Bike Safety Audit Report

Eureka's 4th & 5th Street
Corridor (US-101)

June 2025

Figure 4: 5th Street, with no bicycle facilities.

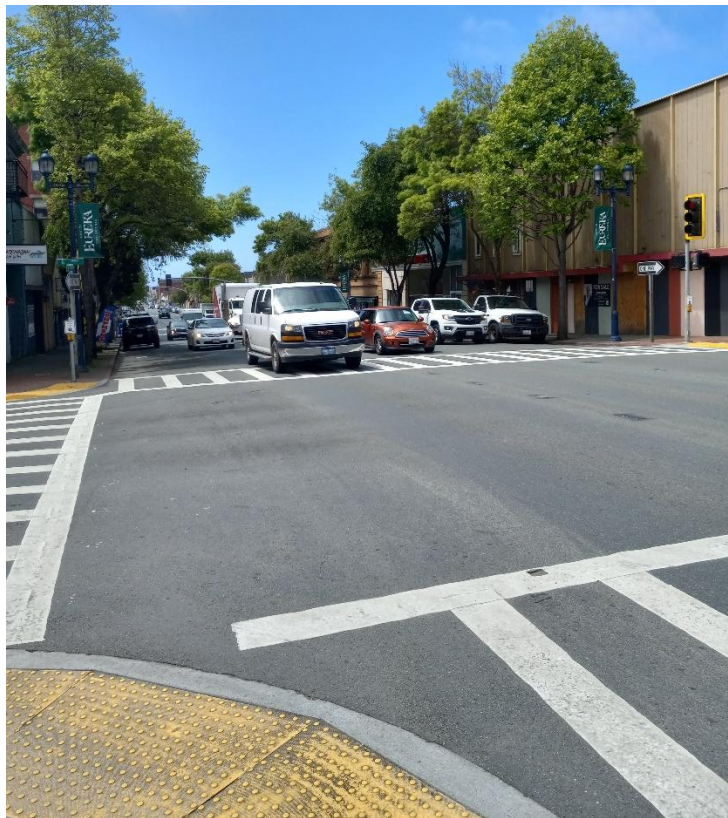
There are no bicycle facilities on 4th or 5th Street or on any of the immediately adjacent cross-street segments. Participants reported that in the absence of bike facilities, they felt unsafe and/or uncomfortable mixing with car and truck traffic on 4th and 5th Streets. Participants reported feeling particularly uncomfortable having to cross multiple lanes of traffic in order to make a left-hand turn off of 4th or 5th Street. They also reported that, due to adjacent parking lanes on both sides of the street, bicyclists are vulnerable to “dooring” from vehicle occupants opening car doors into the bicycling path.

Building protected (Class IV) bike lanes, and specifically turning one of the current general travel lanes or parking lanes into a protected bike lane, was among the most common potential solutions participants identified for making 4th and 5th Streets safer and more comfortable for biking.

POTENTIAL SOLUTION
Convert one of the three existing travel lanes on 4 th and 5 th Streets into a Class IV protected bikeway. Place parking lane between bike lane and travel lanes, but provide enough buffer between parking lane and bikeway to avoid “dooring.”

Figure 5: High traffic volumes and speeds on 5th Street.

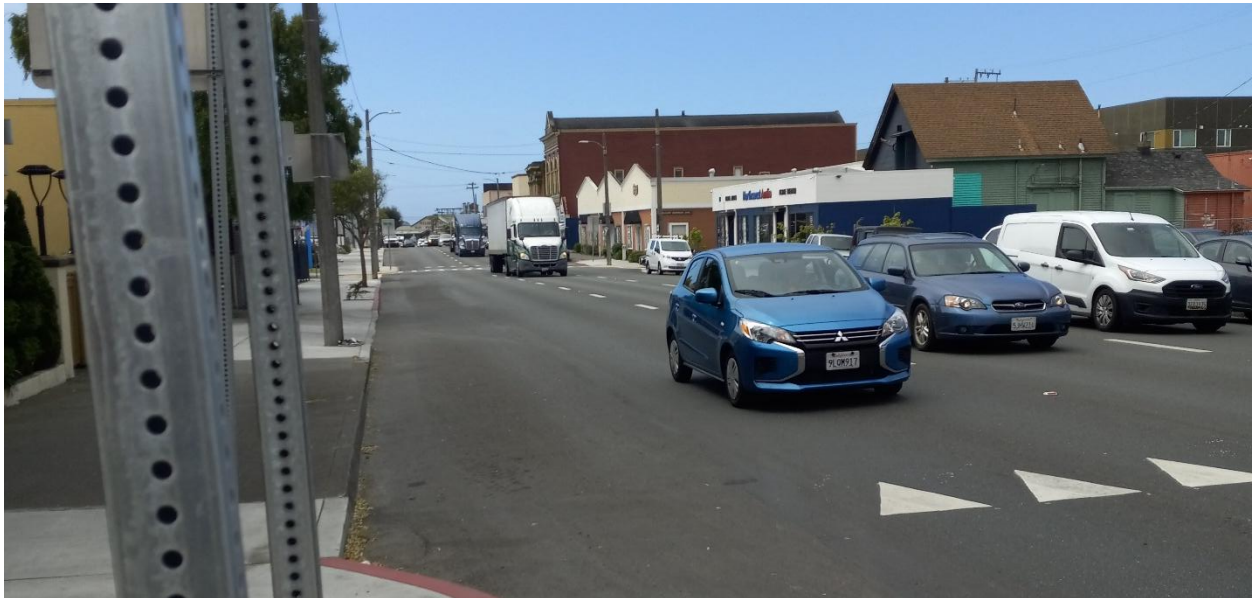
Bike audit participants reported that the high traffic speeds and high traffic volumes on 4th and 5th Street made them feel unsafe and uncomfortable biking on 4th or 5th Street or crossing 4th or 5th Street on a bike, especially given the lack of dedicated bicycle facilities. Lowering traffic speeds and reducing the number of lanes were among the most common potential solutions to this problem identified by participants.

Employ traffic calming measures to significantly reduce vehicle speeds. Convert one of the three existing travel lanes on 4th and 5th Streets into a Class IV protected bikeway, both to reduce speeds and to reduce bicycle crossing distance.
